**AUSTRALIAN
ZIRCONIA LTD**

**A Summary of
Minor Modifications**
to the
Proposed Operations
and/or
**Environmental
Assessment**
of the
Dubbo Zirconia Project

R.W. CORKERY & CO. PTY. LIMITED

April 2014

Figure 2.1 is reproduced on the following page.

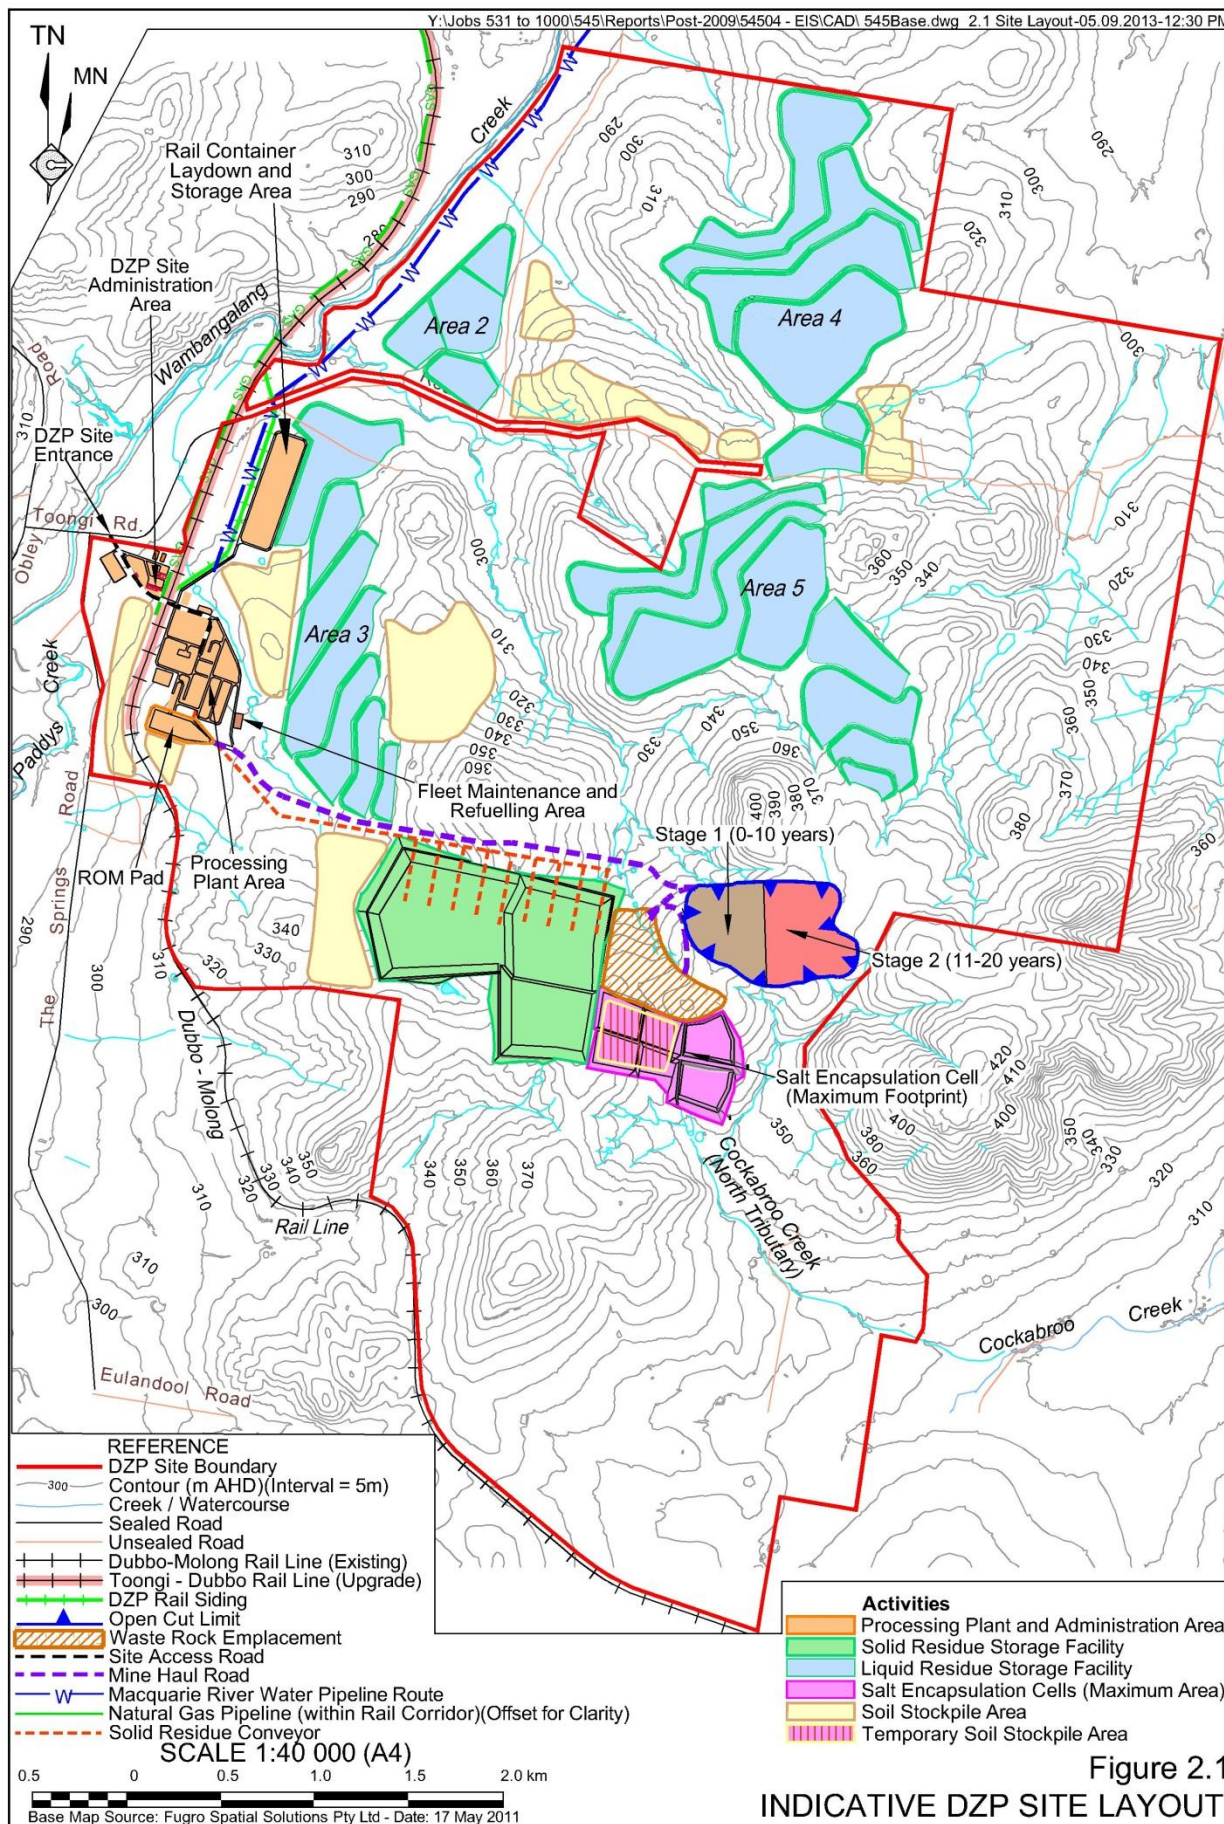
It is confirmed that the maximum development footprint on the DZP Site (as presented on *Figure 2.1* of the EIS) would be approximately 808ha (within the DZP Site of 2 864ha). Component areas of disturbance are as follows:

- Open Cut Mine – 40.3ha.
- Waste Rock Emplacement Area – 20.4ha.
- ROM Pad – 4.2ha.
- Processing Plant and DZP Site Administration Area (incorporating the processing plant and associated reagent storage areas, rail siding and container laydown areas and site offices and administration complex) – 43.3ha.
- Solid Residue Storage Facility – 102.8ha.
- Liquid Residue Storage Facility – 425.4ha.
- Salt Encapsulation Cell – up to 34.6ha.
- Soil Stockpile Areas – up to 129.4ha.
- Internal Haul Roads – 7.3ha.

The proposed minor adjustment to the alignment of the Macquarie River Water Pipeline is provided as **Figure 2.3 (REVISED)**.

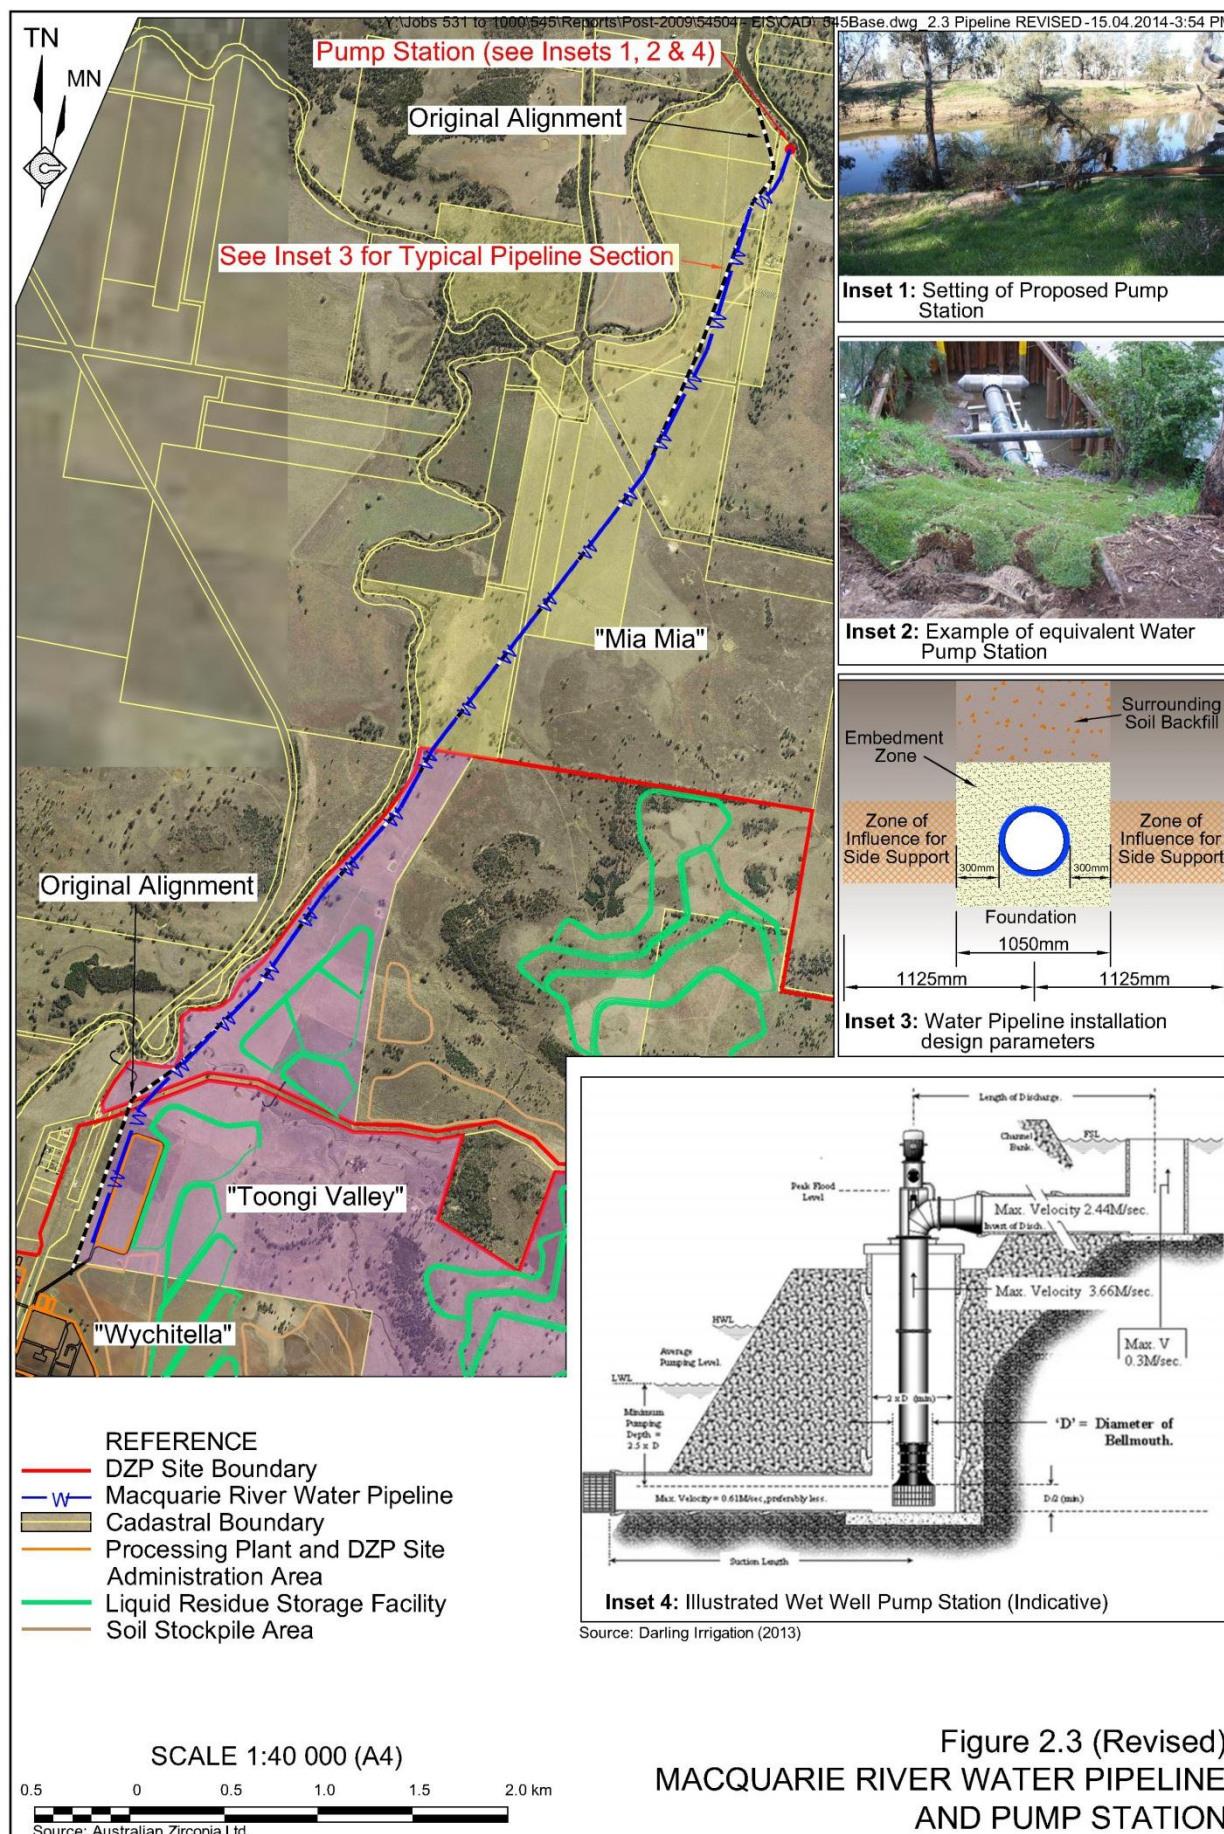
Following further discussion with the land owner of the “Mia Mia” property which fronts the Macquarie River, the proposed location of the pump site has been moved slightly south requiring a small deviation in the alignment of the pipeline on the “Mia Mia” property. *Section 3.1* of the RTS (pp. 6-8) confirms there would be no additional impacts associated with this minor modification.

Figure 2.15 (Revised) presents an up to date plan of the proposed transport route.

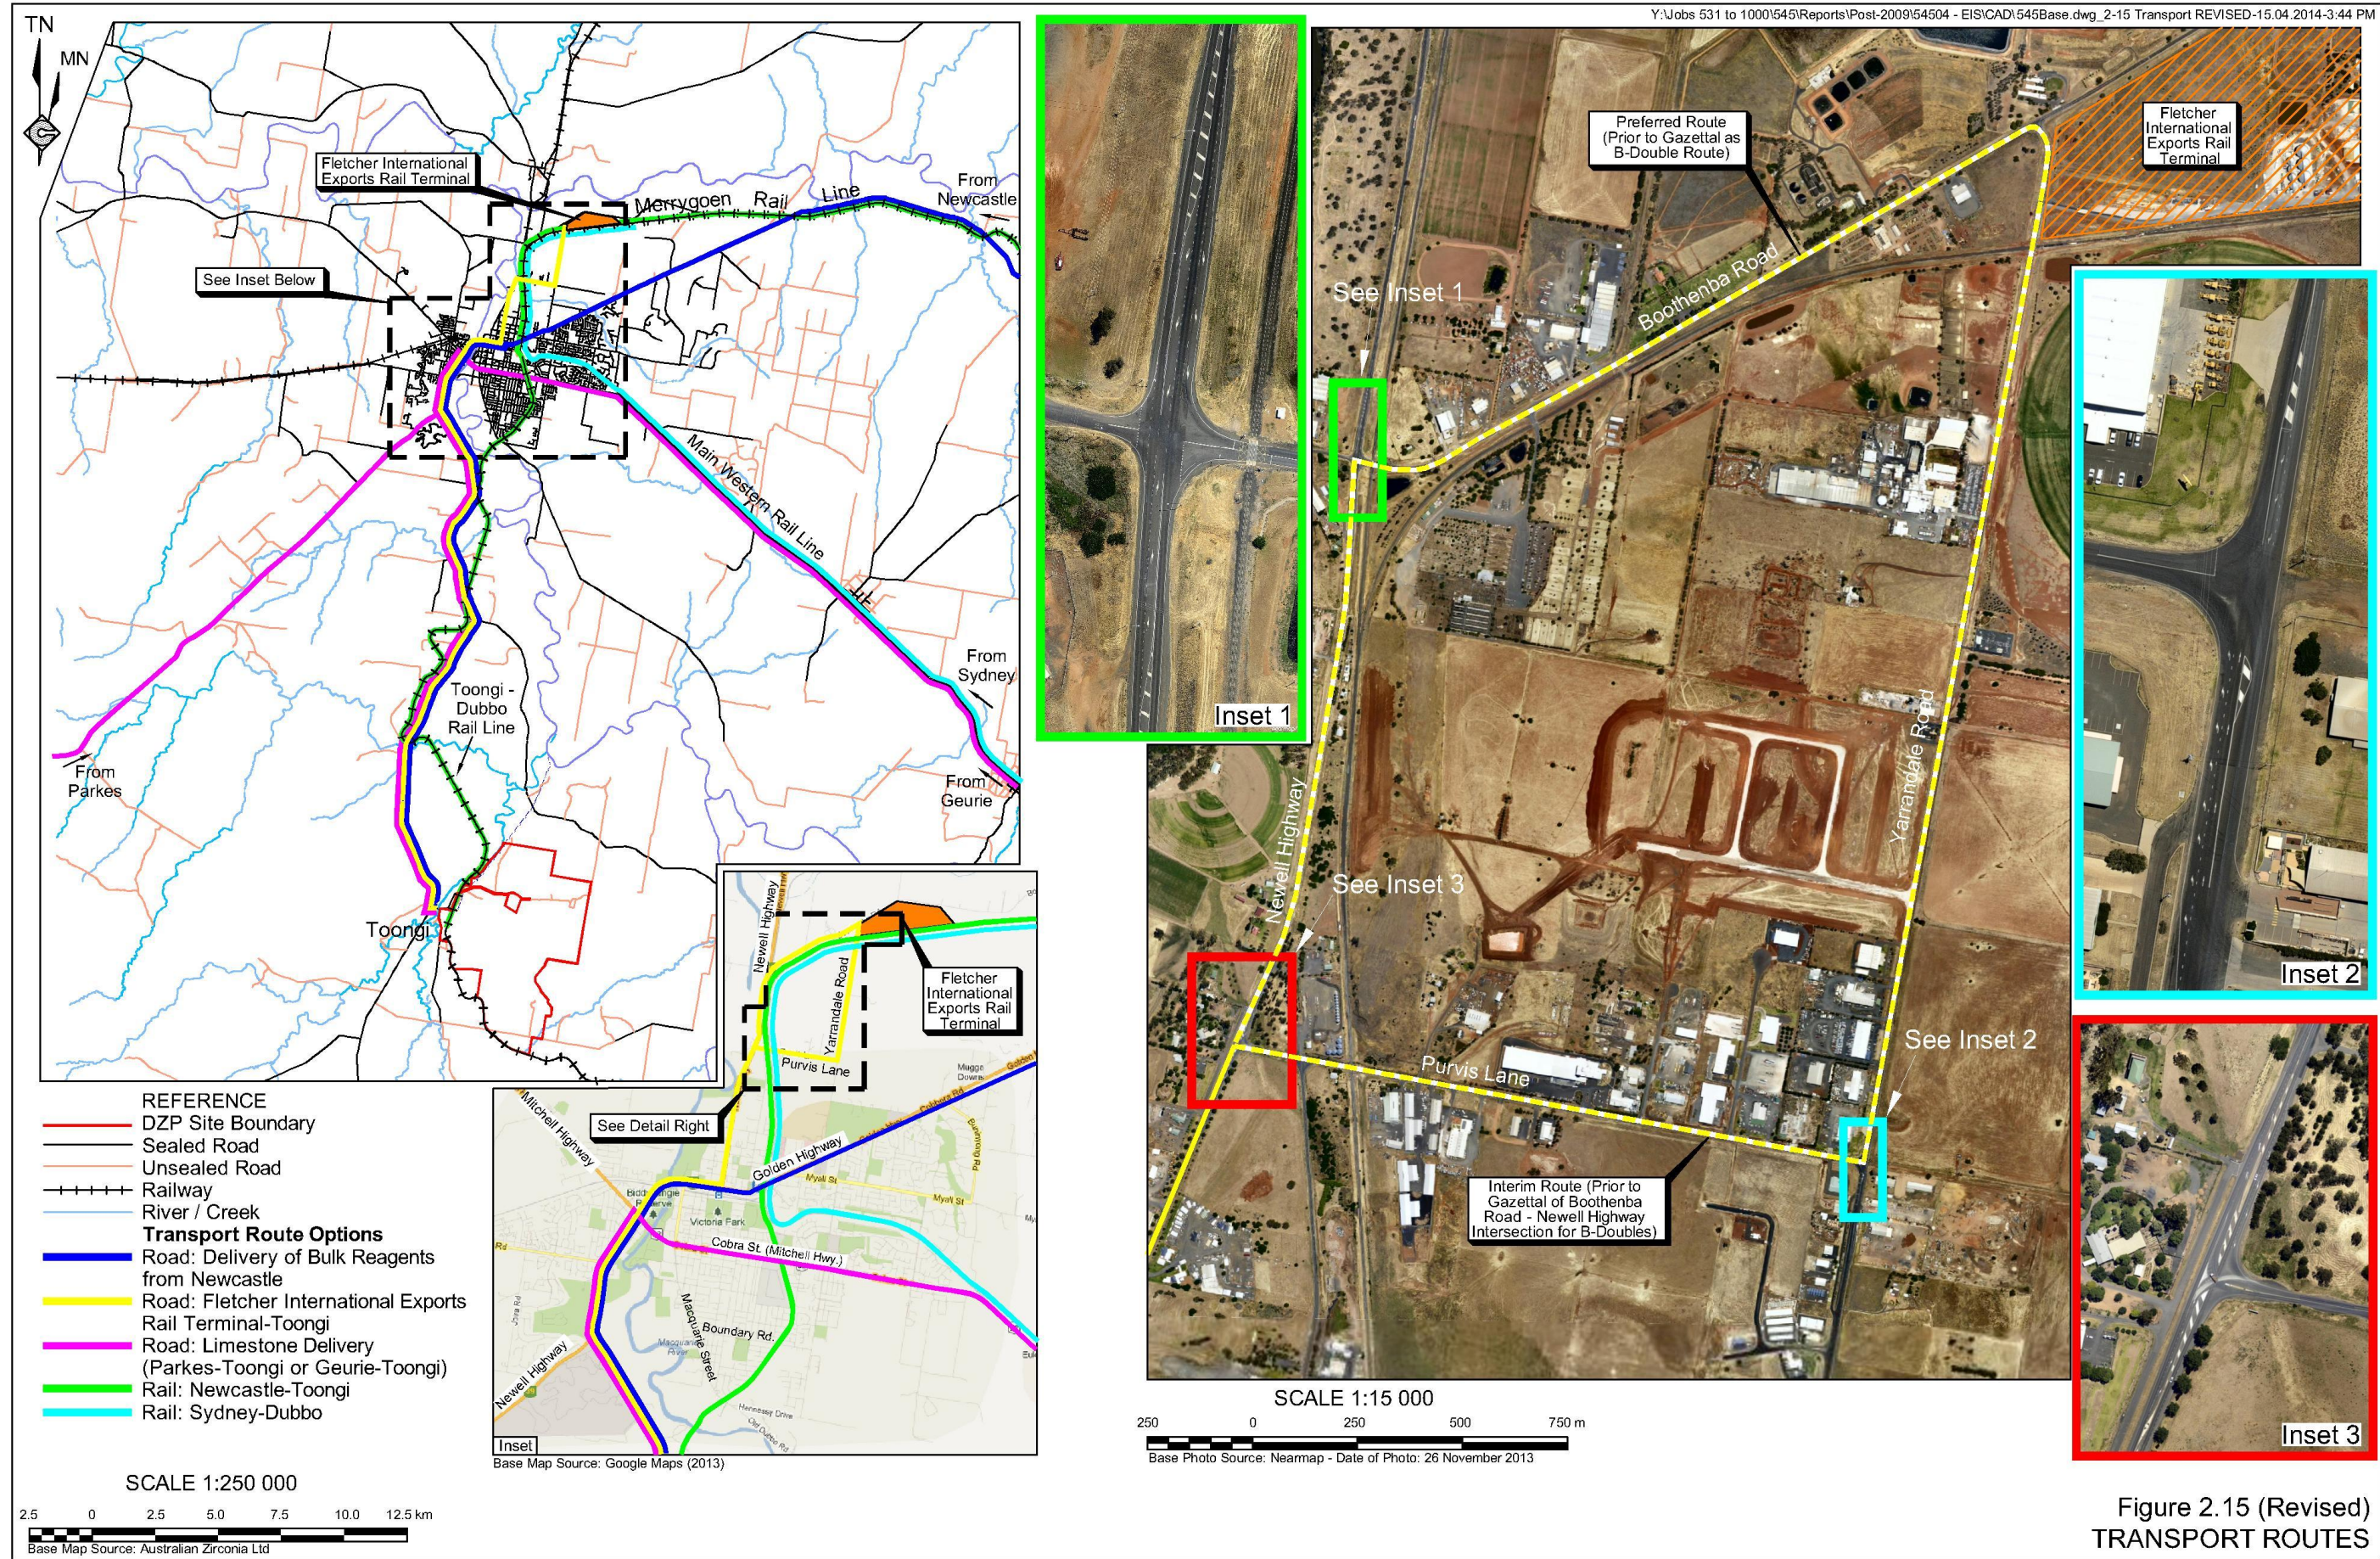
As a result, the Applicant has modified the DZP slightly to include a transport route between Fletcher’s and the Newell Highway incorporating Yarrandale Road – Purvis Lane – Newell Highway (“Purvis Lane route”). This route is a gazetted B-Double and Road Train Route and the Applicant proposes to utilise this route until such time as the Boothenda Road route is gazetted a B-Double Route³.

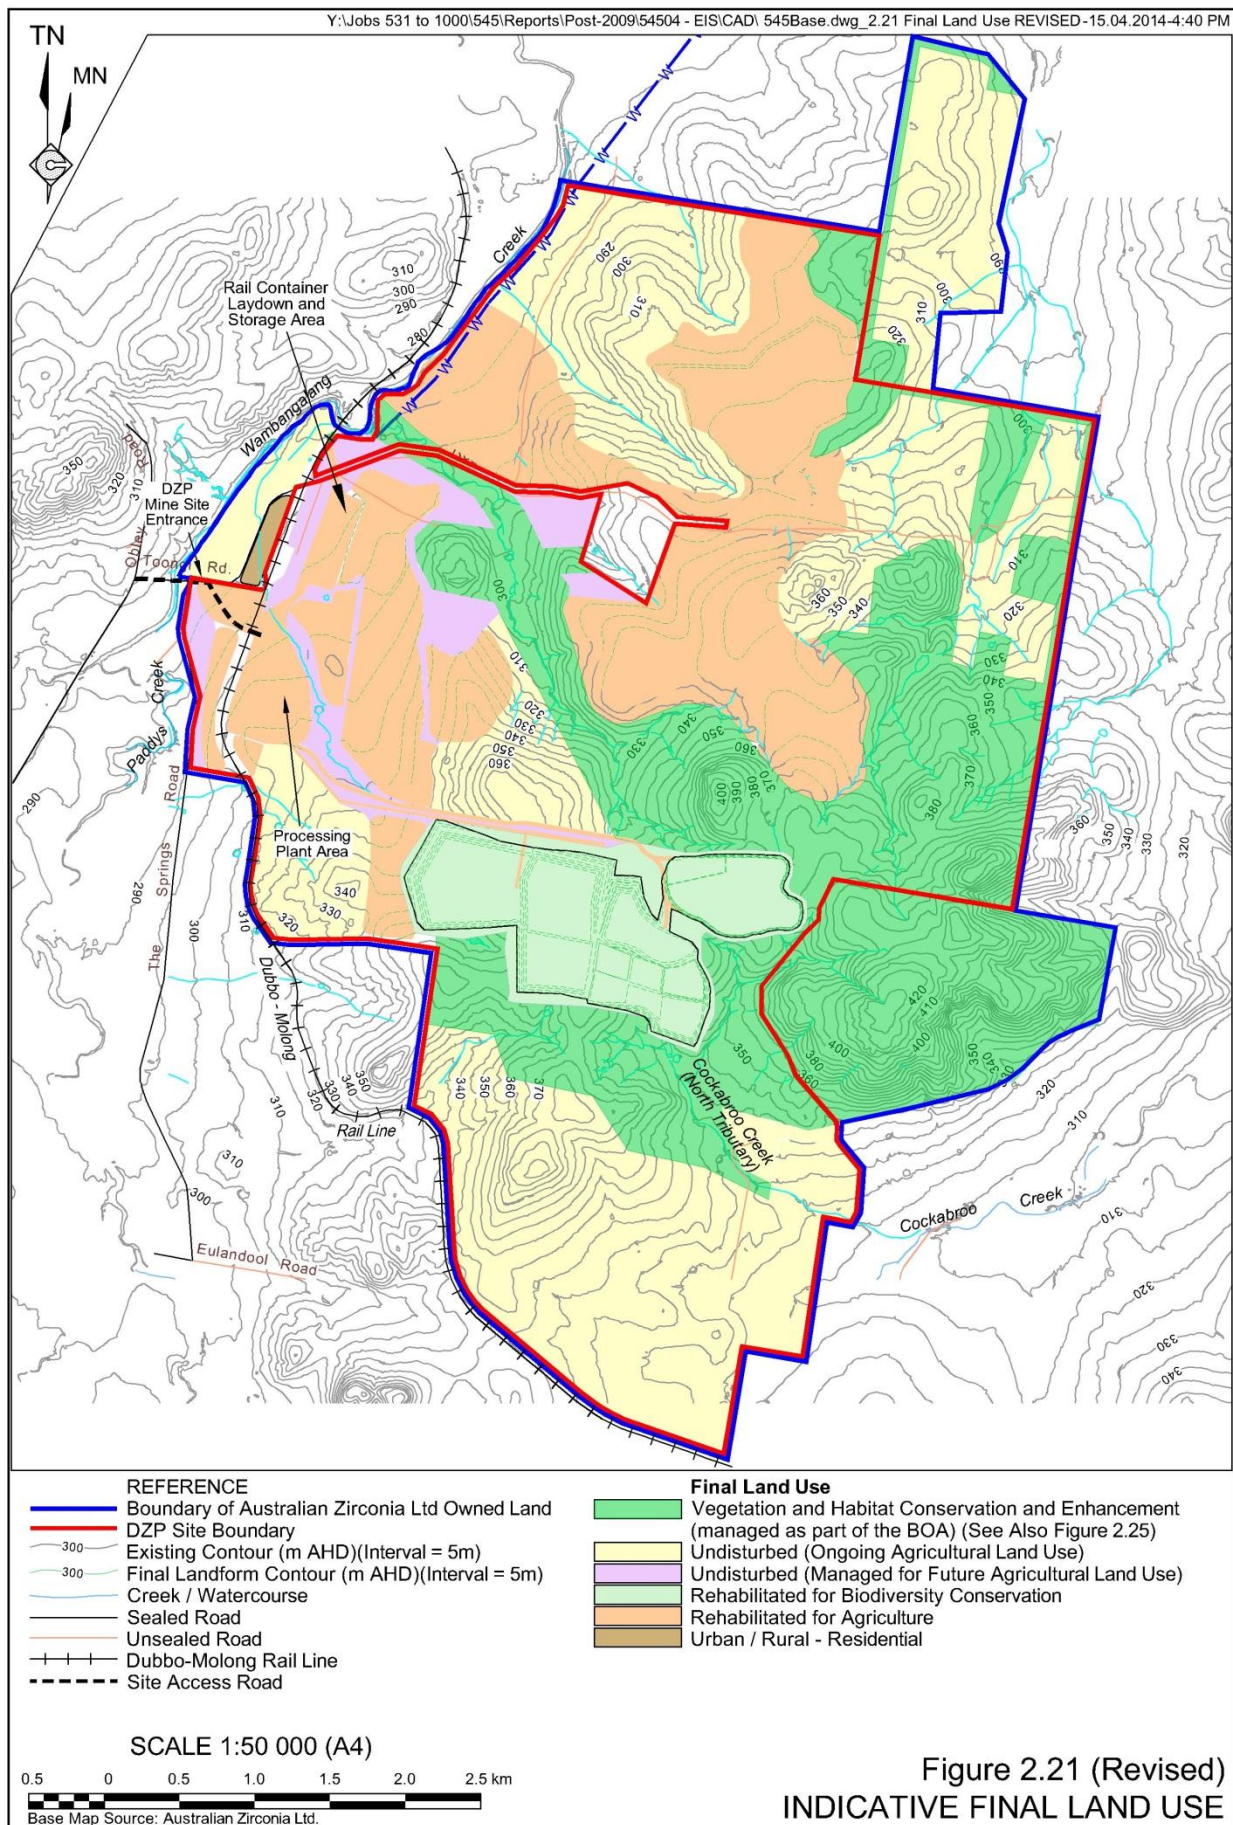
The final land use for the DZP Site presented on *Figure 2.21* and described in *Section 2.17.5* of the EIS includes reference to ‘Potential Future Industrial Use’.

In response, to comments from the Department of Primary Industries – Division of Resources & Energy (DRE) noting that the Applicant must develop a final land use that is consistent with existing surrounding land uses and zonings, the Applicant acknowledges that future industrial use of the nominated sections of the DZP Site occurring on land zoned RU1 Primary Production has not been approved. The final land use and rehabilitation plans have therefore been amended to reflect a return of land within the RU1 zone to agriculture until such time as an appropriate approval is obtained for an alternative development (see **Figure 2.21 (Revised)**).
